**UNION TOWNSHIP BOARD OF TRUSTEES
JANUARY 14TH, 2025 MEETING**

MAJOR AMENDMENT

**EVANS ENGINEERING, Applicant
4375 Ferguson Drive / Parcel ID # 413215E129.**

Staff Report: CASE # 17-86-Z

TITLE:
ELEVATIONS

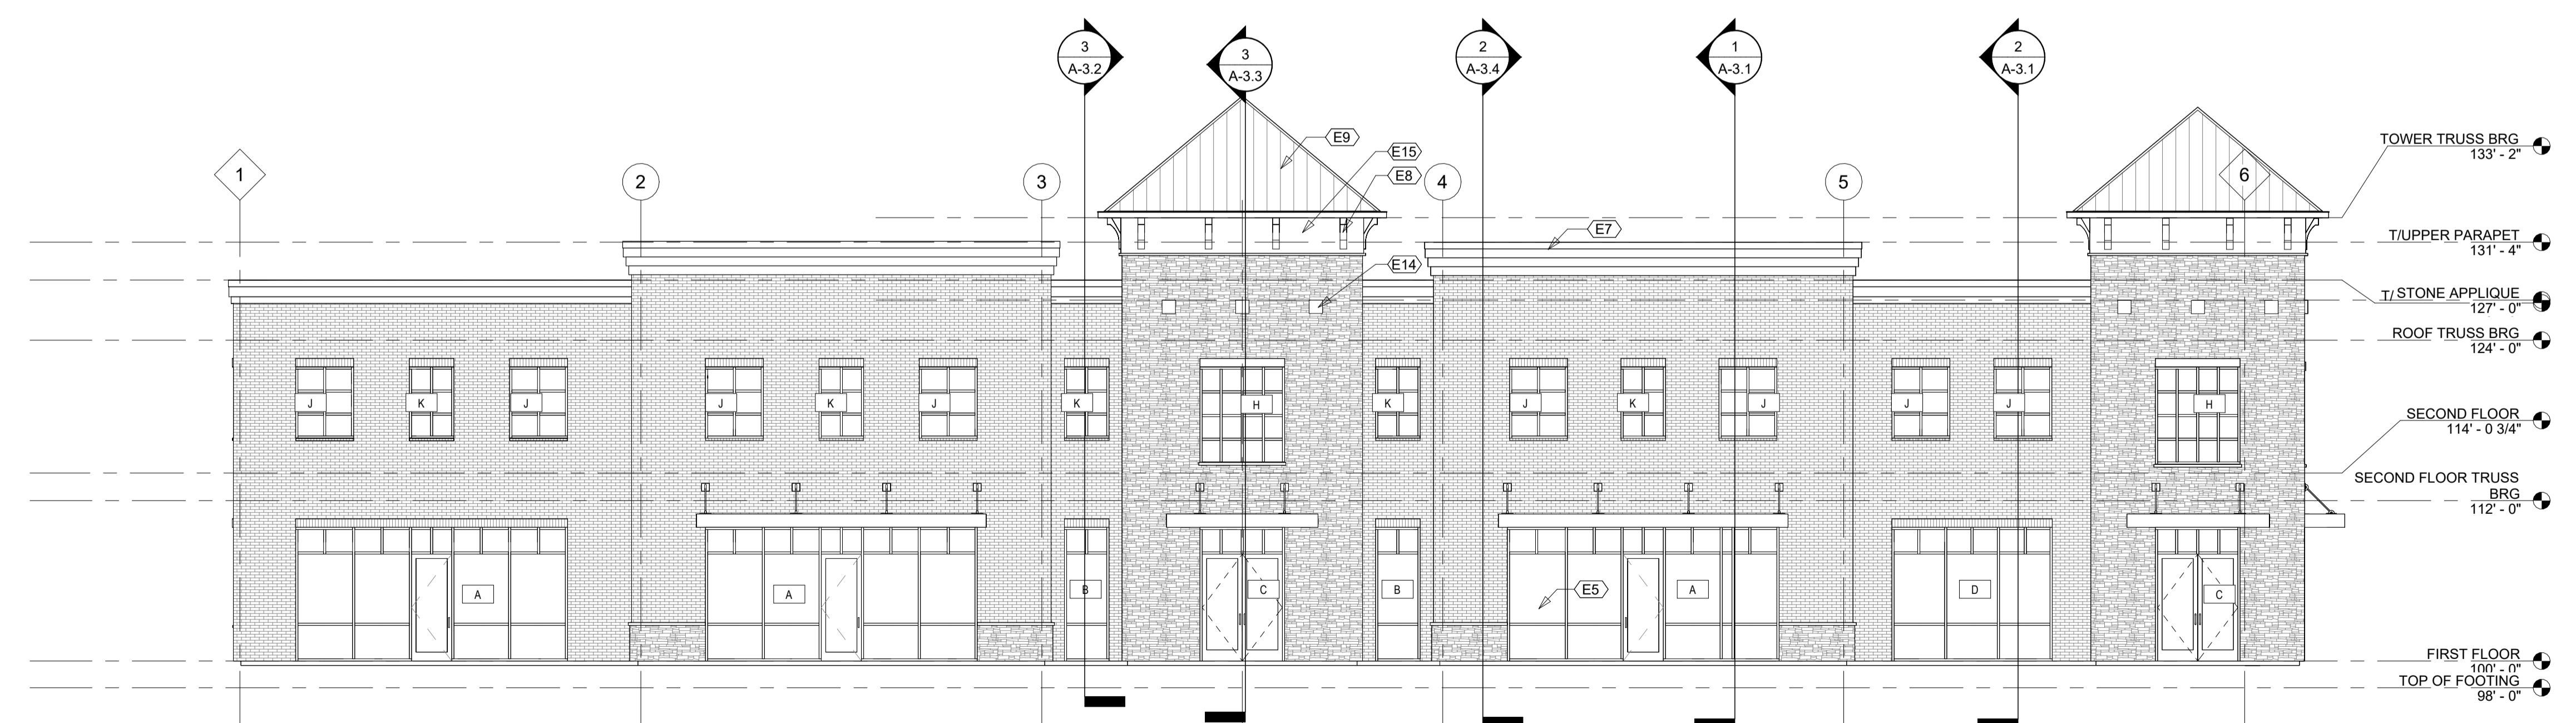
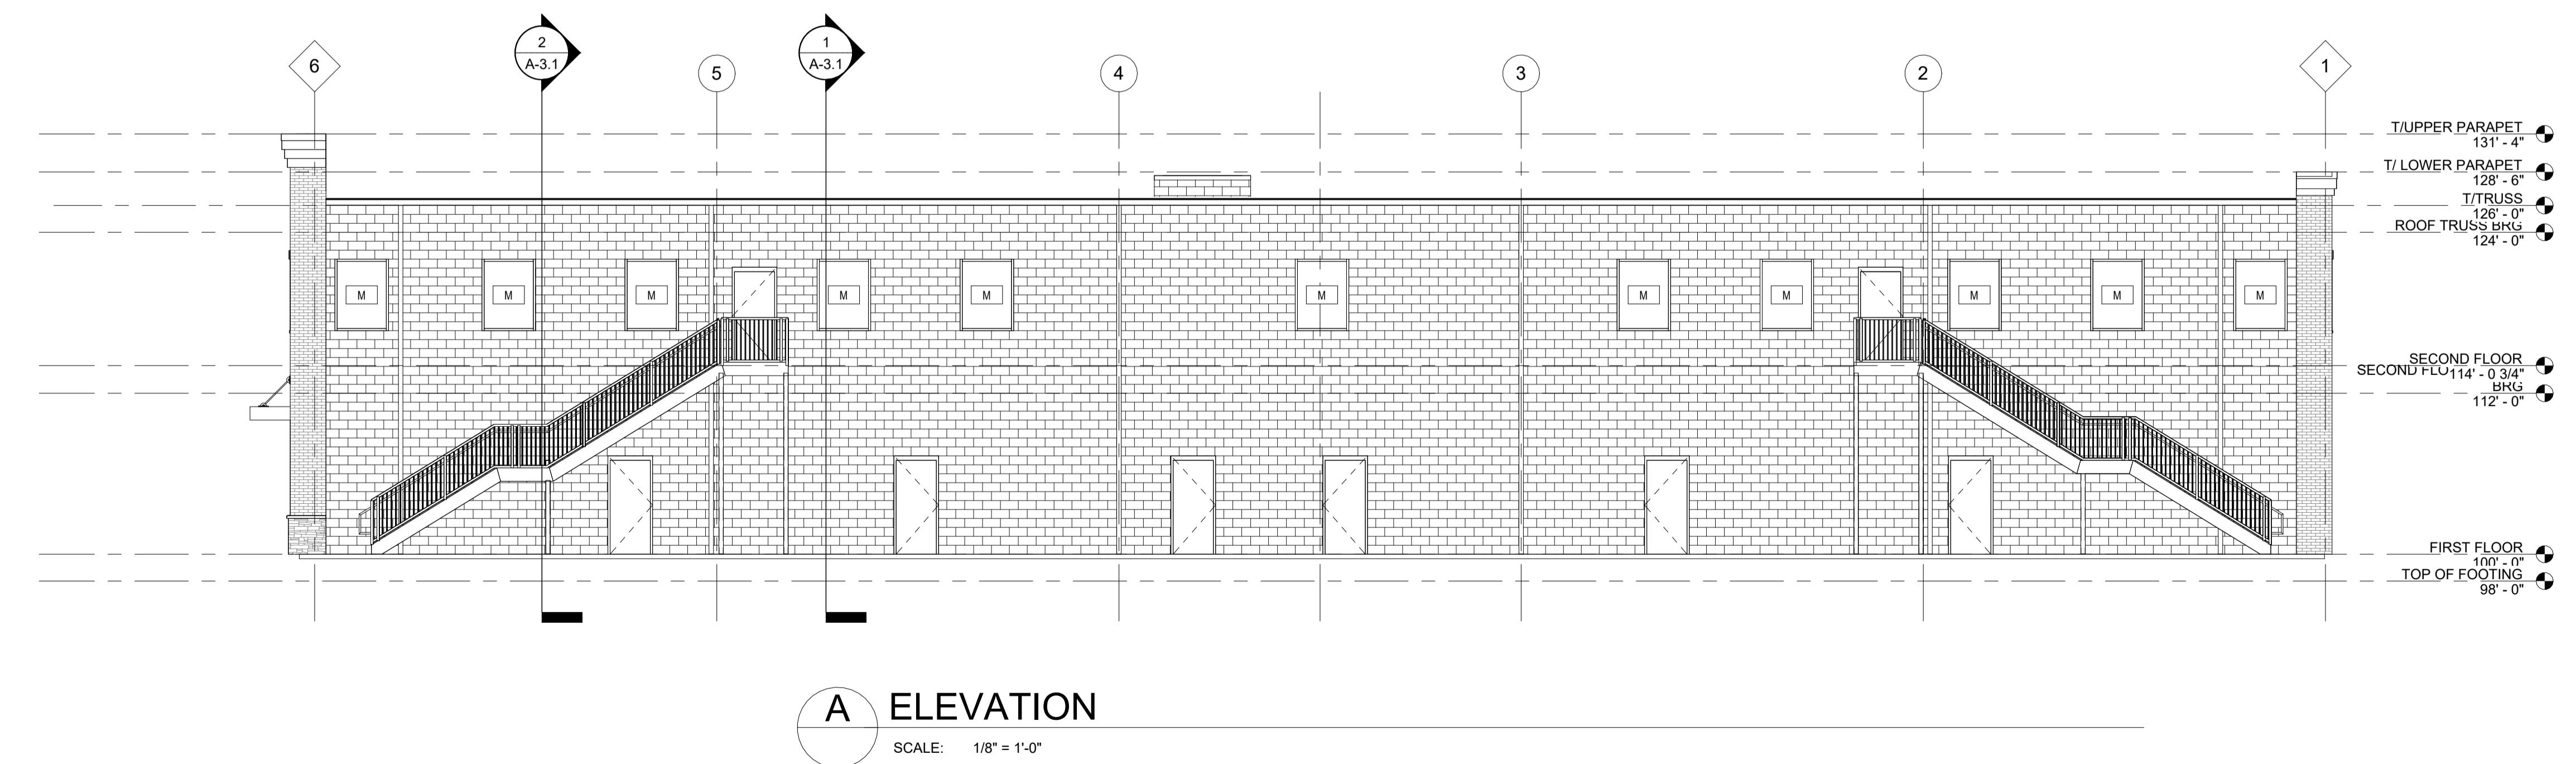
A review of the proposed building elevations appears to show that the principle, visible building elevations will consist primarily of masonry material—with brick and stone veneer(s) and windows comprising most of the structure. Although an initial landscaping plan has been provided, a more detailed plan will ultimately need to be provided to be more consistent with development in the Ivy Pointe Commerce Park area.

2. The Applicant would need to provide additional information with respect to the proposed primary structure improvements—to ensure that the architectural standards and proposed building materials meet the requirements and standards set forth in the Township's Comprehensive Plan and Zoning Resolution. *This is an item that can be addressed administratively by staff.*

SITE DIMENSION PLAN

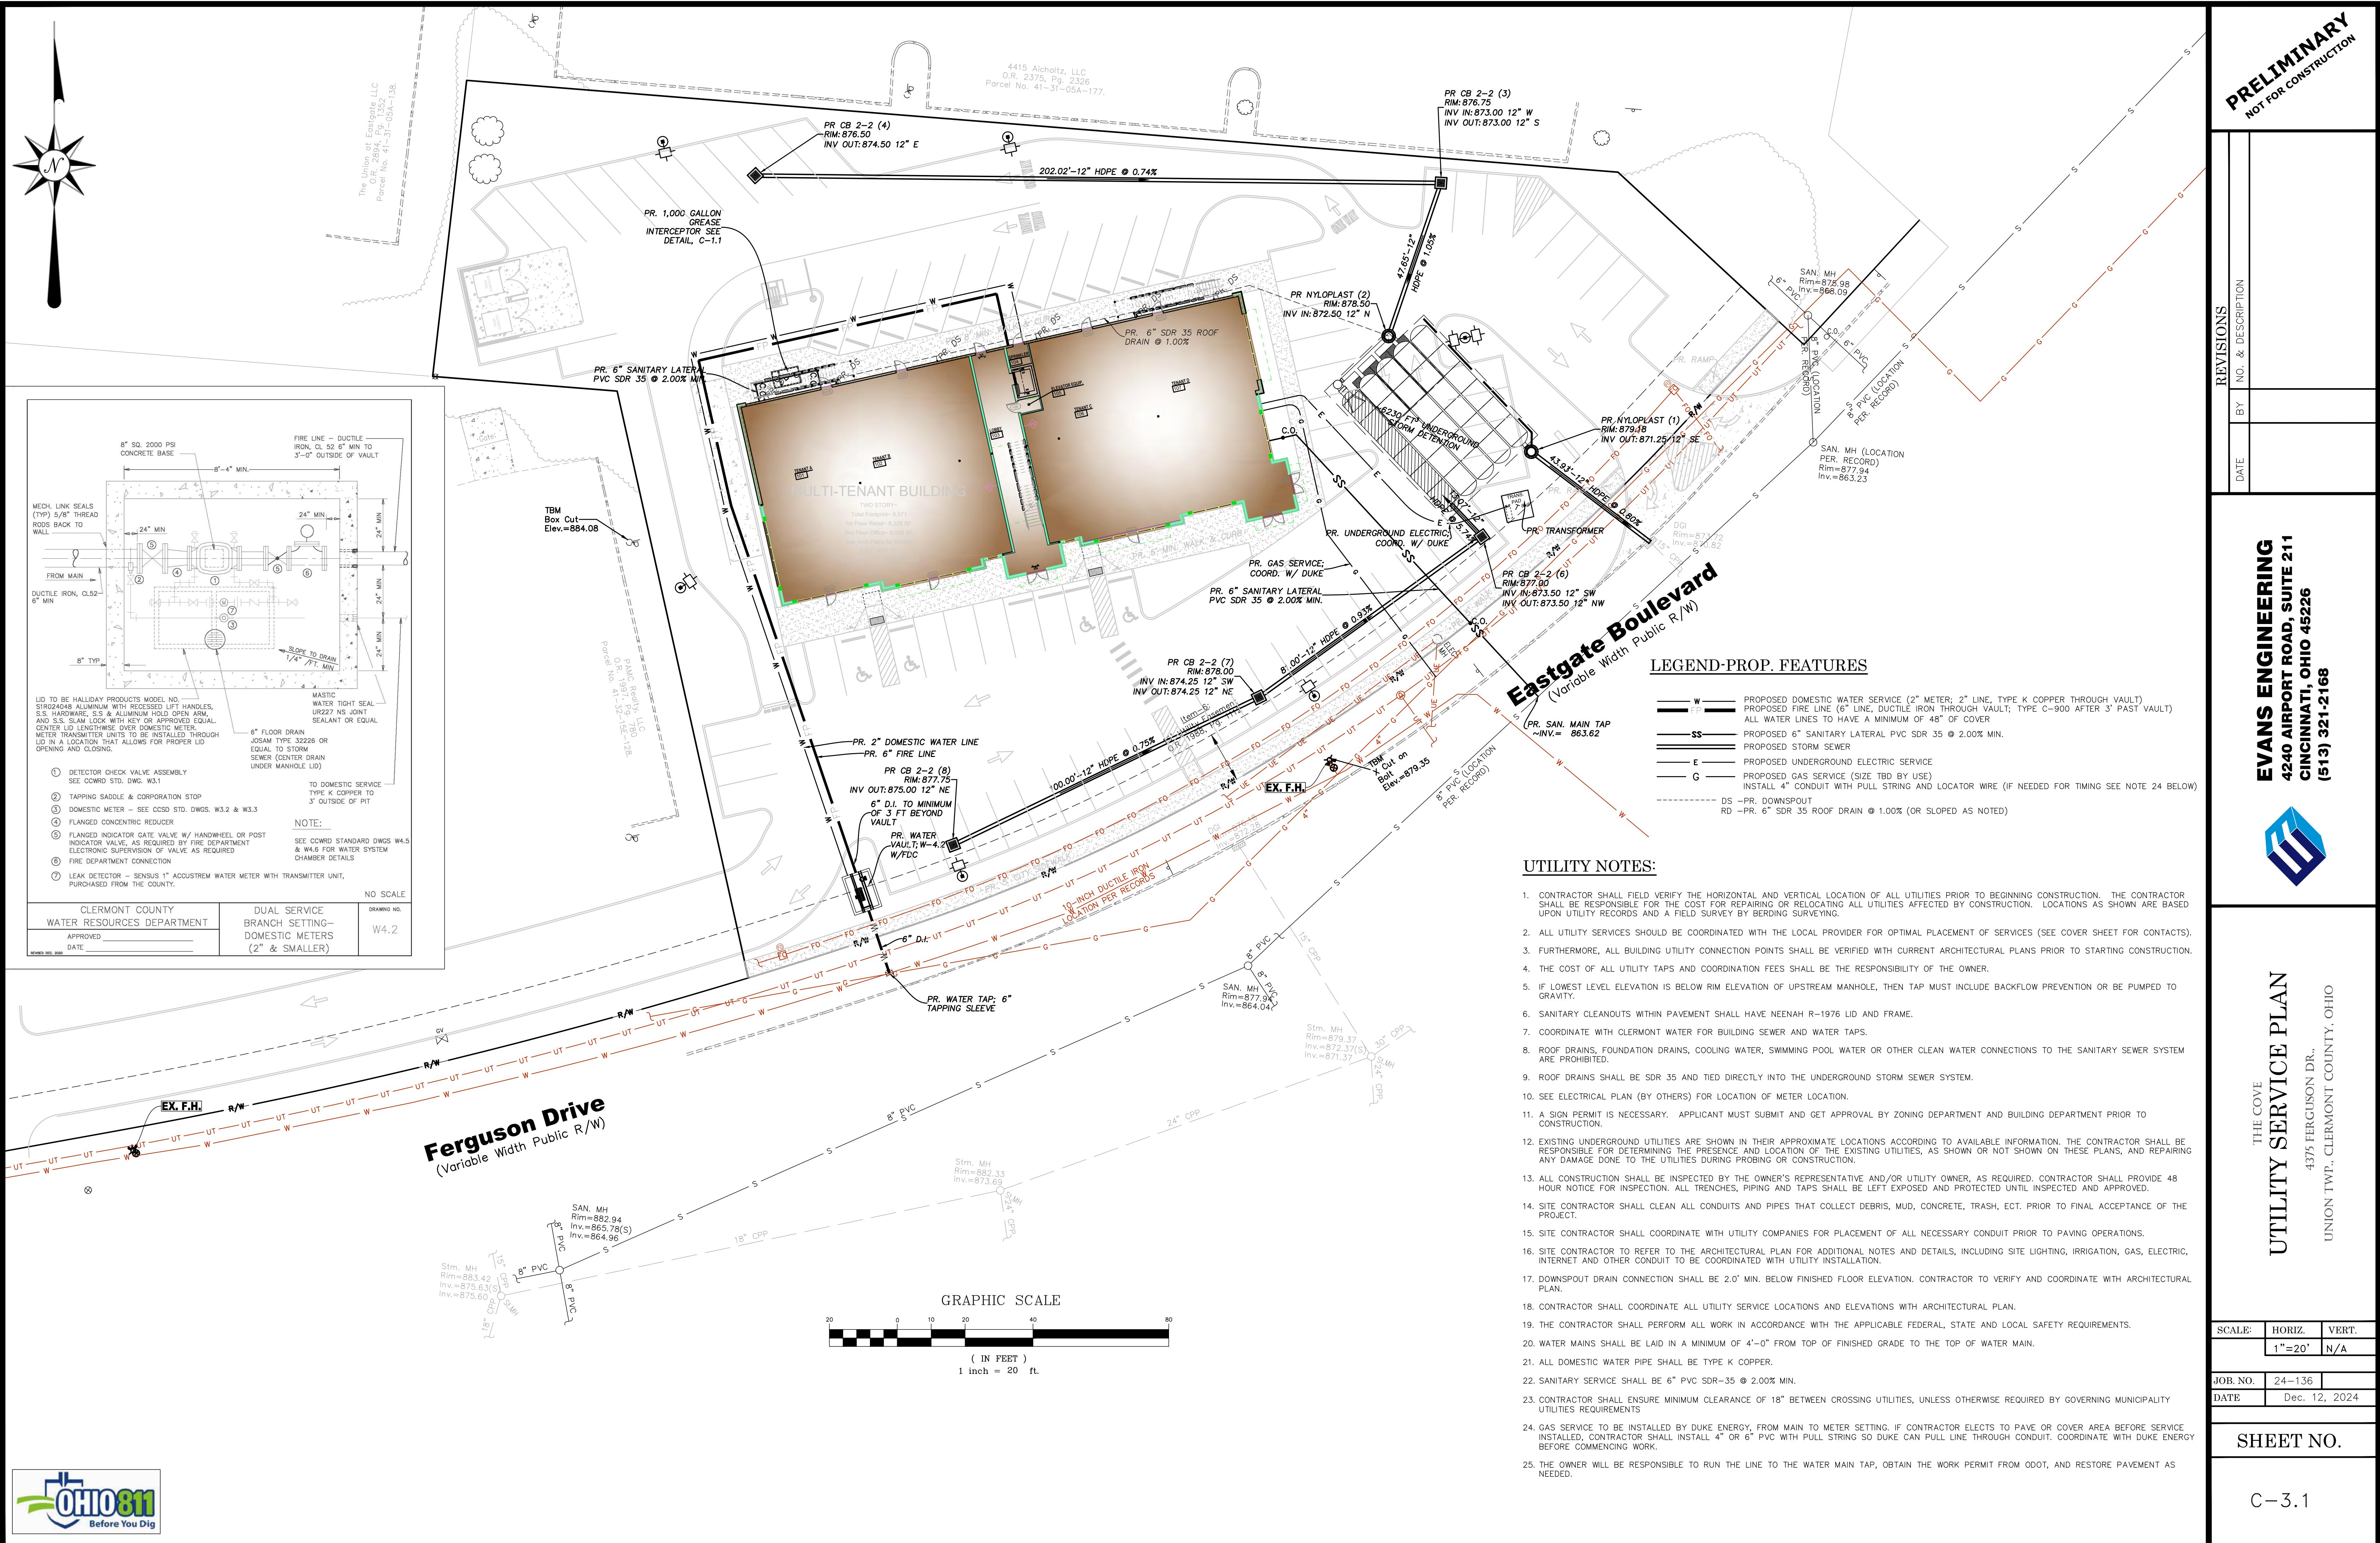
With respect to pedestrian accessibility, there is currently a proposed sidewalk along Eastgate Boulevard / Ferguson Drive. Staff recommends an extension of the proposed sidewalk, as presently shown on the Applicant's plans, so that in total it would run along the Eastgate Boulevard / Ferguson Drive road right-of-way from the northeast corner of the subject property to the southwest corner of 4371 Ferguson Drive (near the shared access point). Staff also recommends an additional pedestrian connection to the adjacent Union multi-family residential property—to benefit both the residents at The Union and the future businesses located within The Cove.

4. The Applicant would need to install a sidewalk along the Eastgate Boulevard / Ferguson Drive road right-of-way from the northeast corner of this particular property to the southwest corner of 4371 Ferguson Drive (near the shared access point). Staff recommends an additional pedestrian connection to the adjacent Union multi-family residential property. *This is an item that could be addressed administratively by staff.*

5. The Applicant would need to remove the three (3) parking spaces to the southwest of the proposed drive-thru, to limit potential points of vehicular conflict and also allow for a passing lane. The parking space closest to the proposed dumpster would also need to be removed, to limit to limit potential points of vehicular conflict and access to the dumpster.
